**EGG-SSRE-9926
November 12, 1991**

**EVALUATION OF EPRI DRAFT
REPORT NP-7065 - REVIEW
OF NRC/INEL GATE VALVE
TEST PROGRAM**

**Prepared for the
U.S. NUCLEAR REGULATORY COMMISSION**

**Robert Steele, Jr.
John C. Watkins
Kevin G. DeWall**

Figure 6. Isometric drawing of a typical Mark I RWCU supply line.

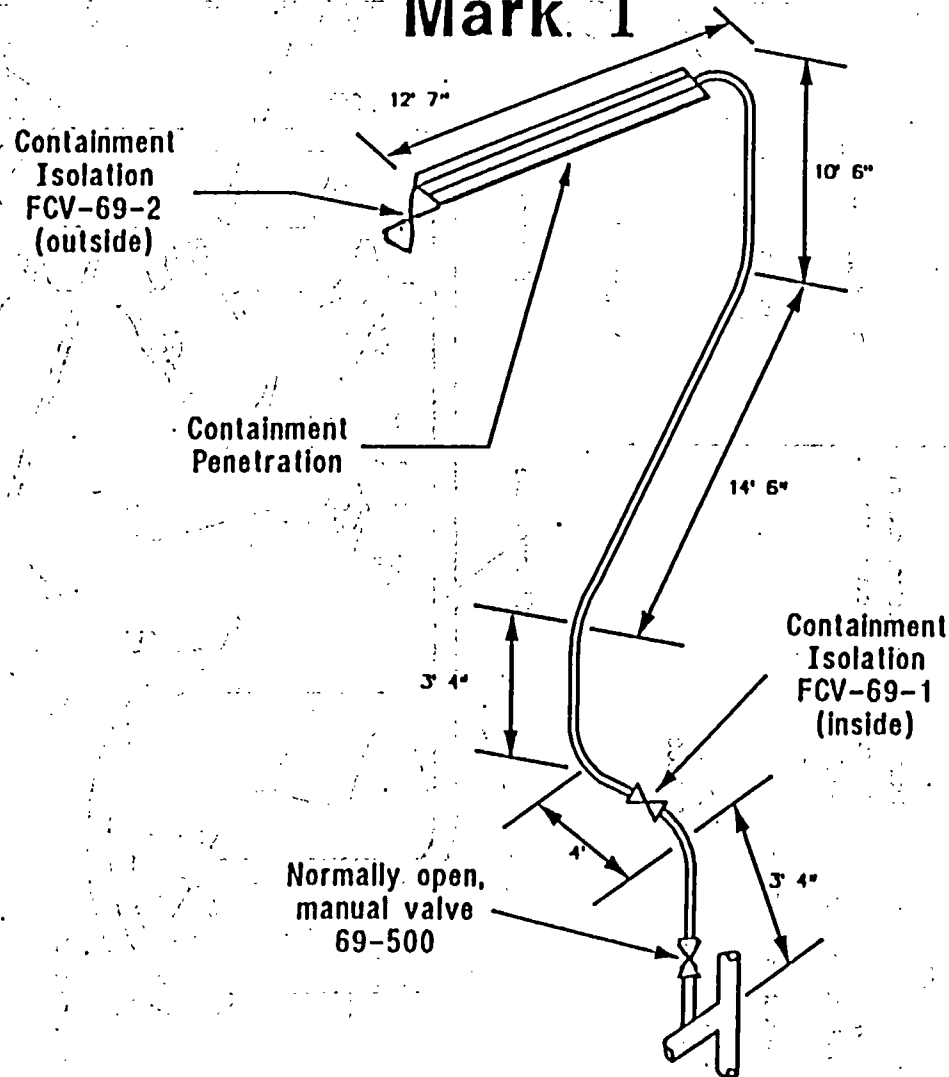
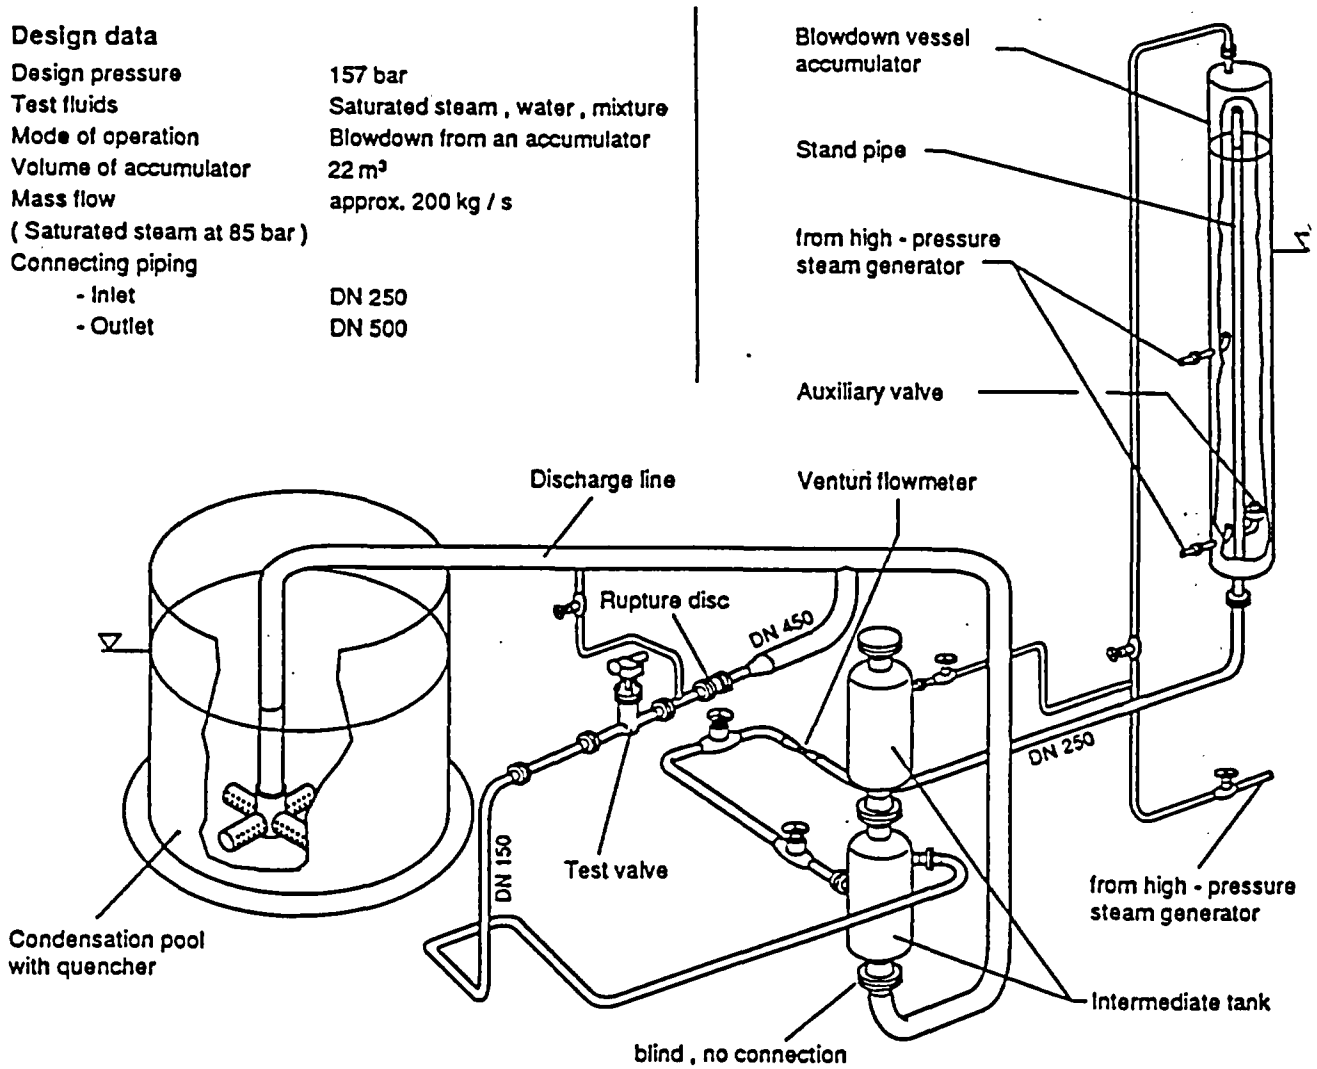
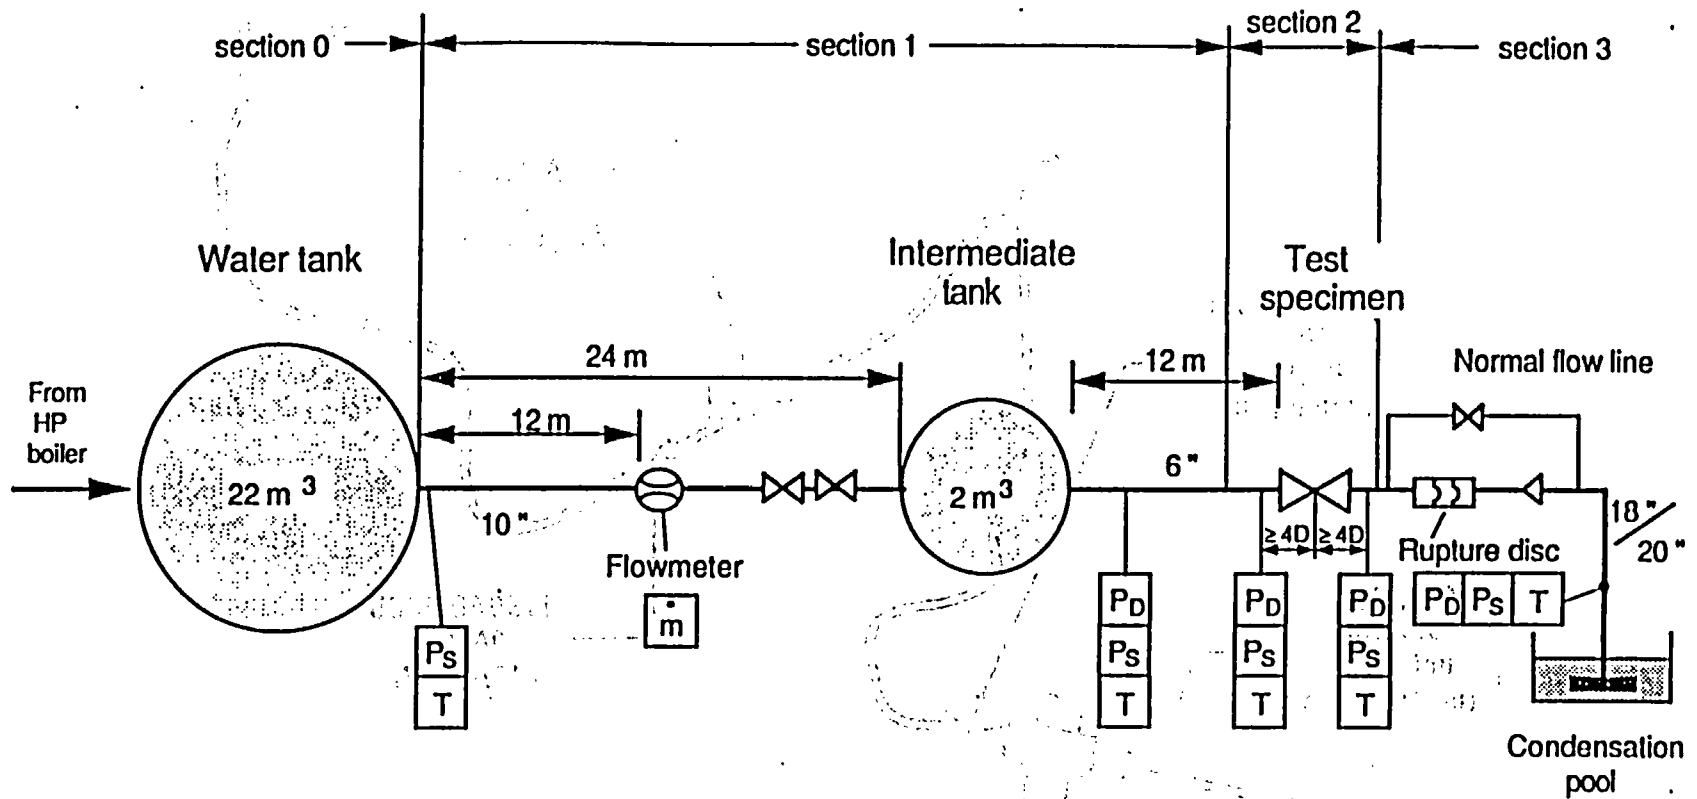
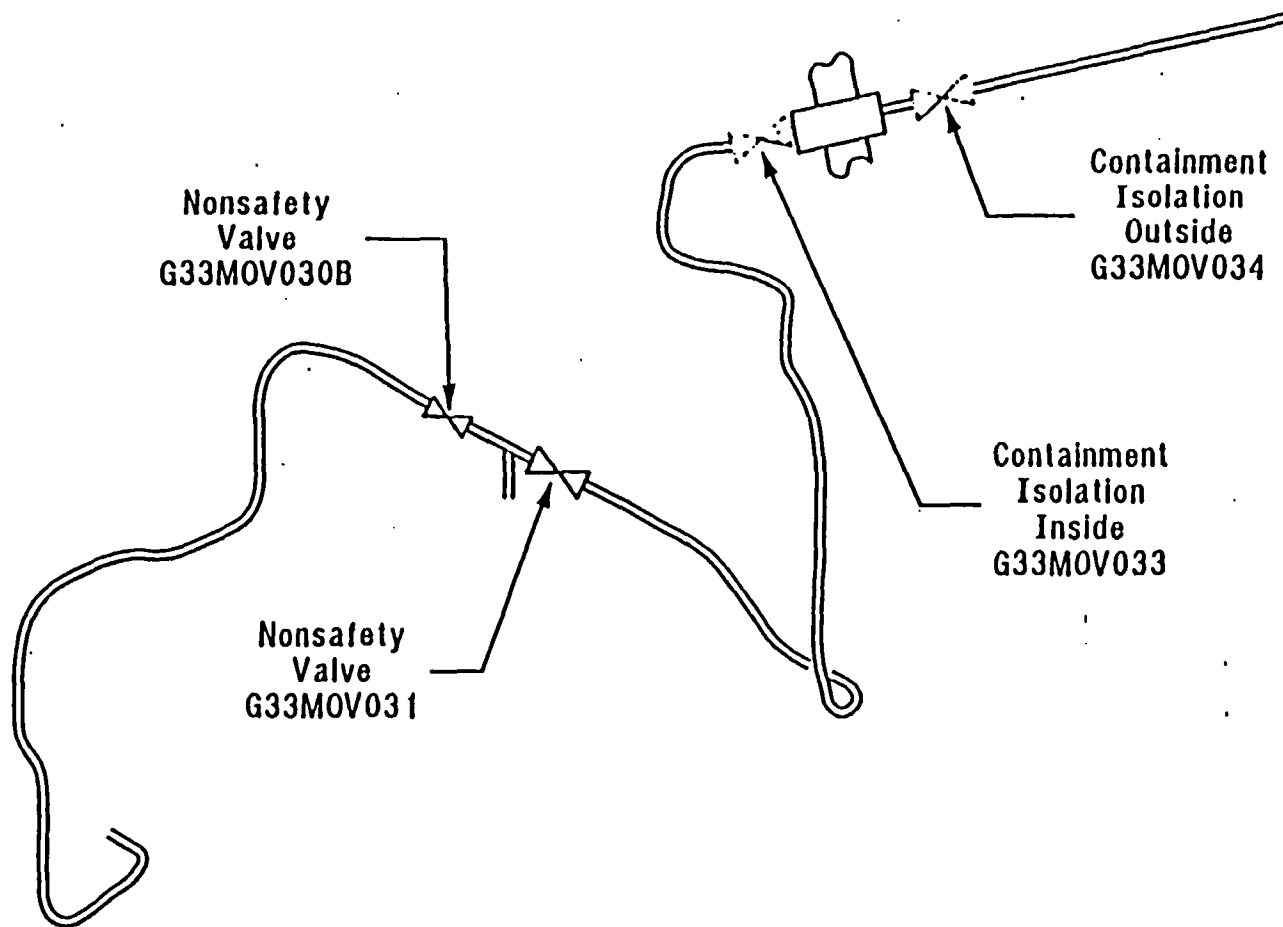
The opposite was our concern: did we have too much line loss in the test loop to model the less complicated plant piping systems? Figure 6 is an isometric drawing of a Mark I RWCU supply line, Figure 7 is an isometric drawing of the Phase II 6-in. test loop, and Figure 8 provides the dimensions of the Phase II test loop. The test loop has about twice the line losses of a Mark I RWCU supply line. In contrast, Figure 9 is an isometric drawing of a much more complicated Mark II RWCU supply line, where the line losses have a greater effect on the pressure profile at the valve. It is easy to see that line losses in these systems vary significantly from plant to plant. To address the issue of line losses, we established, within facility limitations, the test target pressures at the valves. The parametric testing at higher and lower pressures provided an adequate range of pressure histories to account for any creditable line loss scenario.

Figure 10. INEL correlation for tests with less than 70°F subcooled fluid.

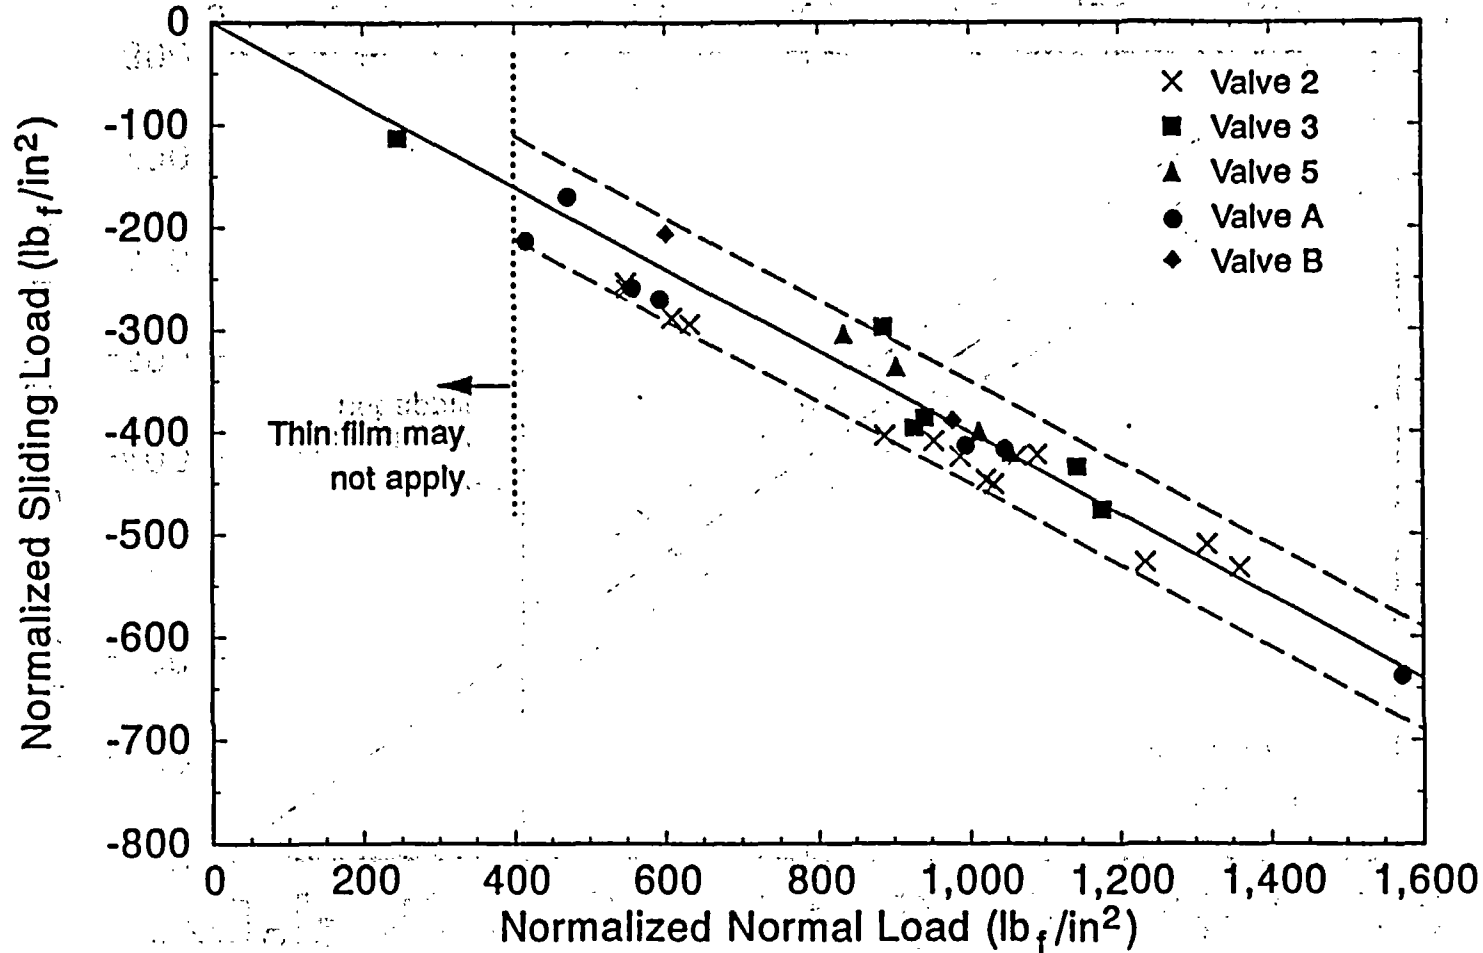
friction factor is defined as the sliding load divided by the normal load, or the slope of the solid line on each of these figures). Two of the Valve A tests in Figure 10 (darkened circles) had nitrogen flow through the valve; these two data points lie near a normalized normal loading of 400 lb_i/in². As can be seen, the on-the-seat sliding versus normal loads for these Valve A tests line up well with those of all of the rest of the valves. This comparison indicates that the nitrogen/water vapor mixture did not affect the on-the-seat performance of the valves. This issue is discussed in depth in Section 3.4.6, and the thick film/thin film lubrication discussion in Appendix C provides further insight into the observed behavior.

Figure 13. Photograph of the entire Valve A disc after the Phase I tests.

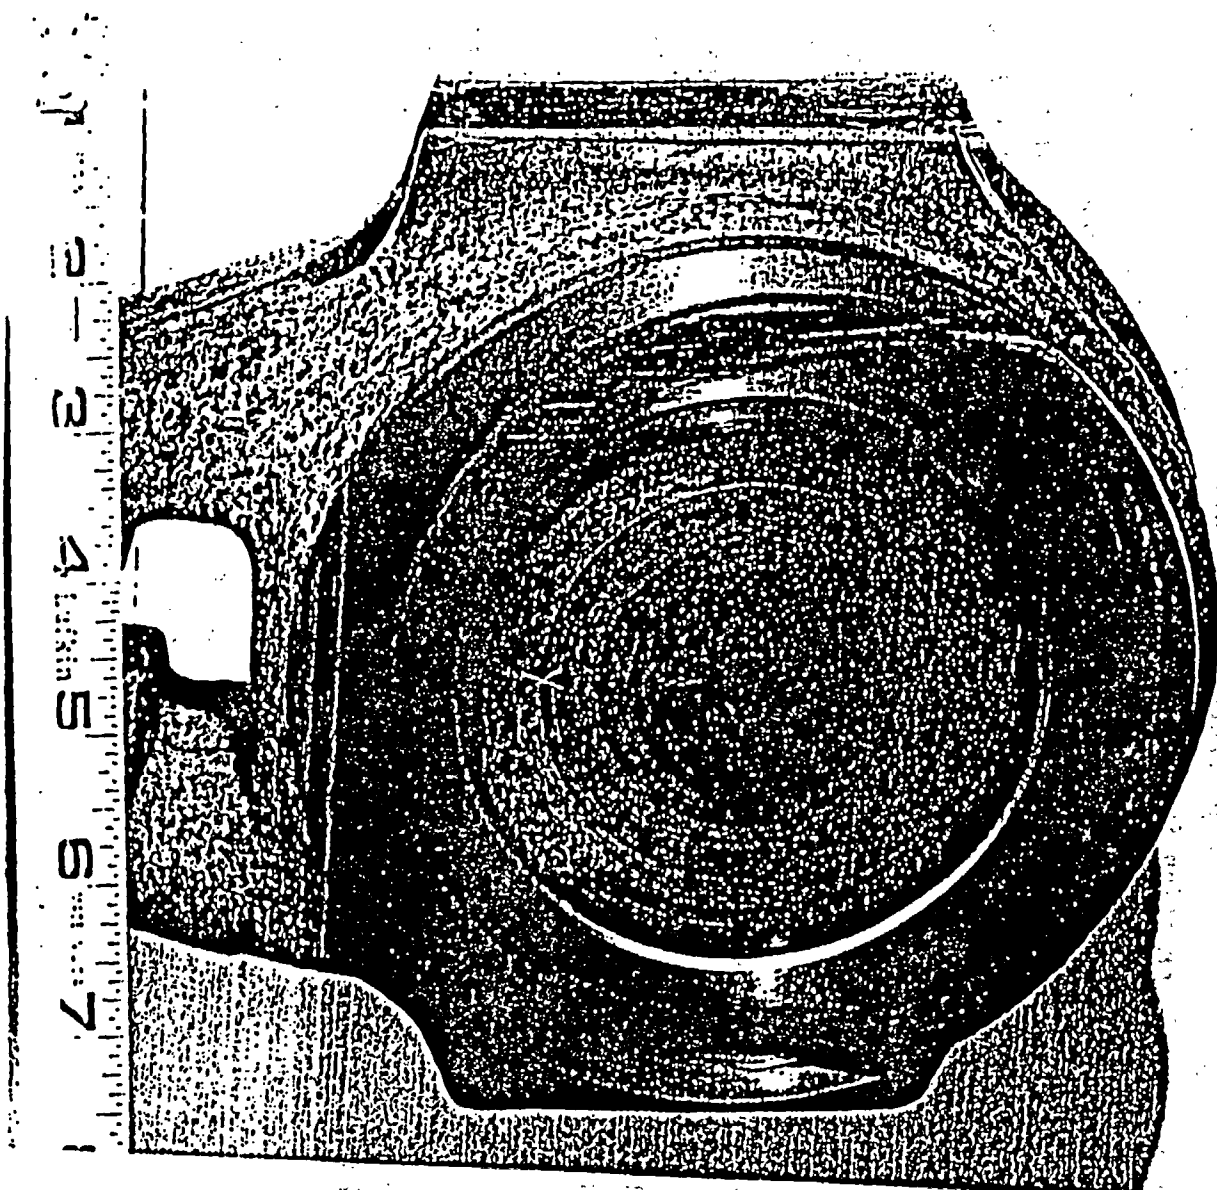
Figures 13 and 14 are photographs of the Valve A disc taken after the Phase I tests. These photographs show the condition of the seating surface and the sharp edge discussed later in this section. The valve was manufactured for the Phase I test program by Anchor/Darling, and to quote the EPRI report, "Anchor/Darling indicates that Valve A is similar in design features to a large population of flexible wedge gate valves they have manufactured and supplied to nuclear power plants." Valves supplied to nuclear power plants with similar design features to Valve A would therefore be expected to perform in a similar fashion when exposed to similar conditions. Valve A performed unpredictably in the Phase I test program due to internal damage caused by the flow loadings.

Figure 16. Stem force for Valve 2 during Step 25 of Test 1.

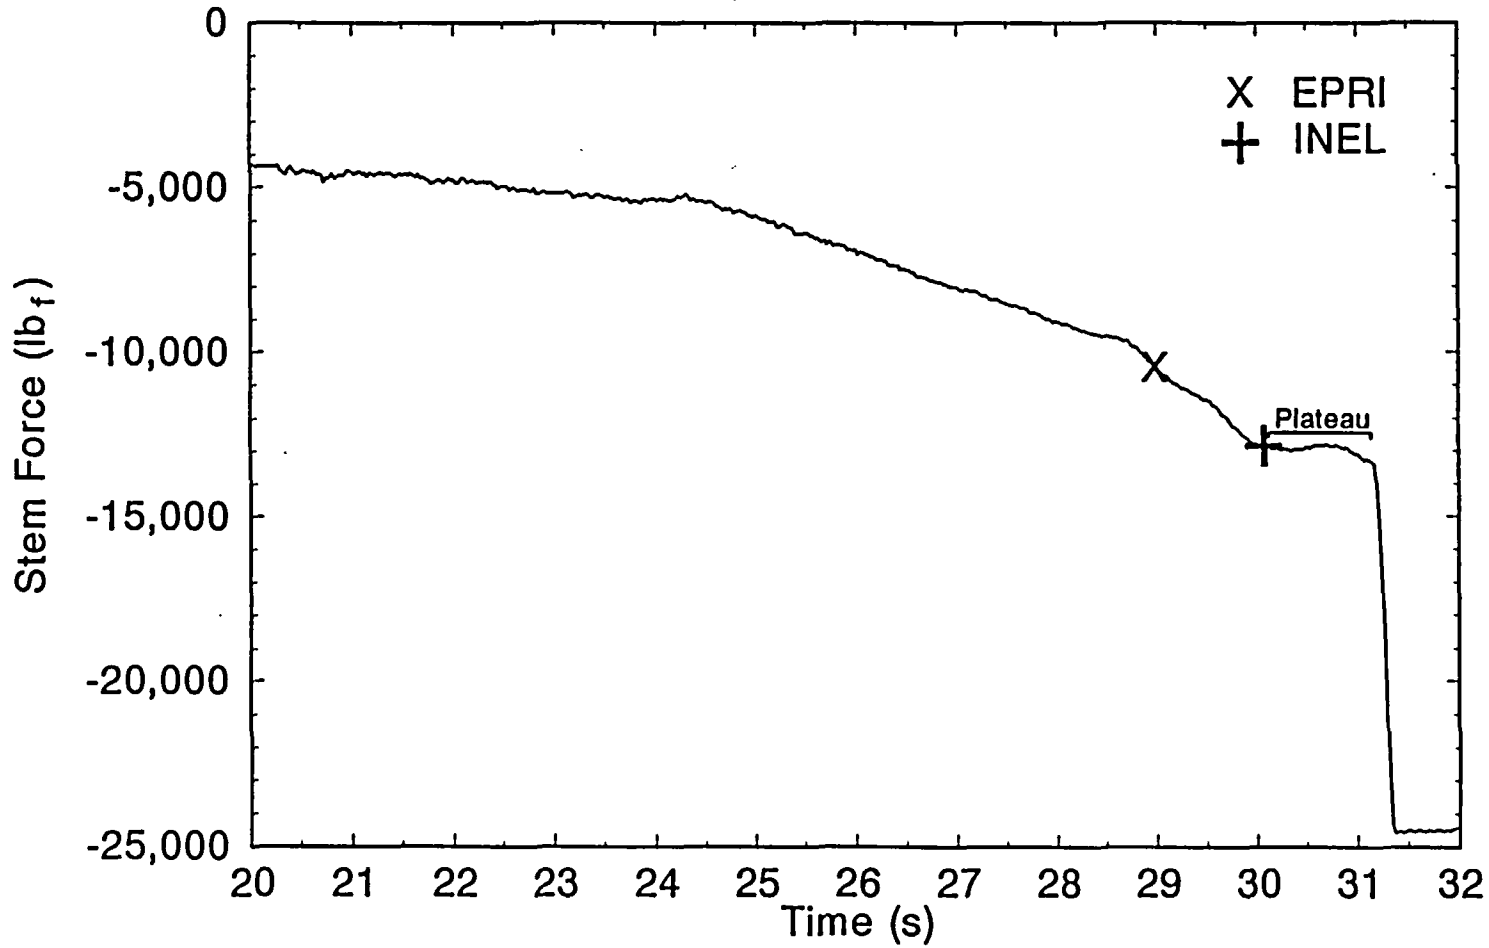
By way of example, Figures 16 through 18 show the stem force, the upstream, bonnet, and under-the-disc pressure, and the downstream dynamic pressure histories for Valve 2 Test 1 Step 25. Also shown on each of these figures is the point identified as flow isolation as shown on Table 6-1 of the EPRI report and the point used by the INEL to assess the response of the valve.

While it is true that downstream dynamic pressure is a better indication of flow isolation than downstream static pressure, we have found the plateau on the stem force trace (Figure 16) to be the best indicator of flow isolation, as confirmed by the convergence of the three valve pressures and by the decay of the downstream dynamic pressure. For predictable valves, this plateau represents the maximum force before wedging. The point identified in the EPRI report as flow isolation typically lies before this plateau rather than on it, thus yielding too low a value for the stem force necessary to achieve true flow isolation.
